## Product Change Notification / NTDO-10HHGT120

CCB 3012.001 Final Notice: Qualification of MMT as an additional assembly site for selected Atmel ATTINY104 device family available in 8L SOIC (150mils) package.

### **PCN# NTDO-10HHGT120**

## Pre Change

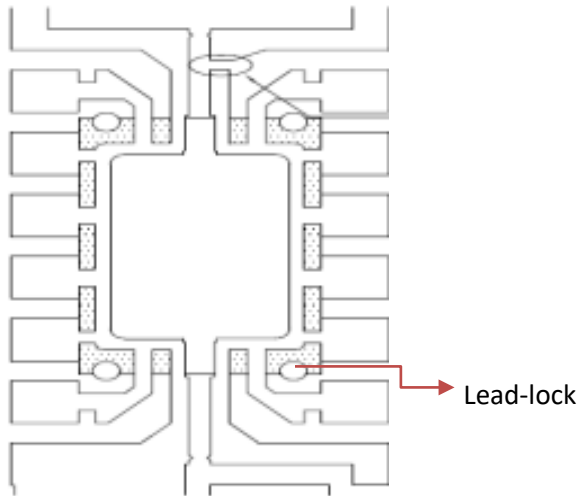
<b>Assembly Location</b>	Lingsen Precision Industries, Limited (LPI)
<b>Leadframe Material</b>	C194*
<b>Leadlock</b>	Yes
<b>Paddle Size</b>	90x90 mils

## Post Change

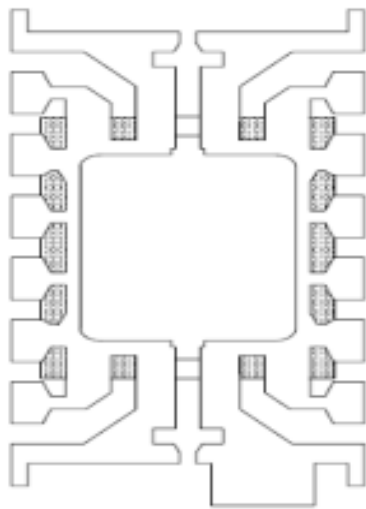
<b>Assembly Location</b>	Microchip Technology Thailand Branch (MMT)
<b>Leadframe Material</b>	A194*
<b>Leadlock</b>	No
<b>Paddle Size</b>	104x150 mils
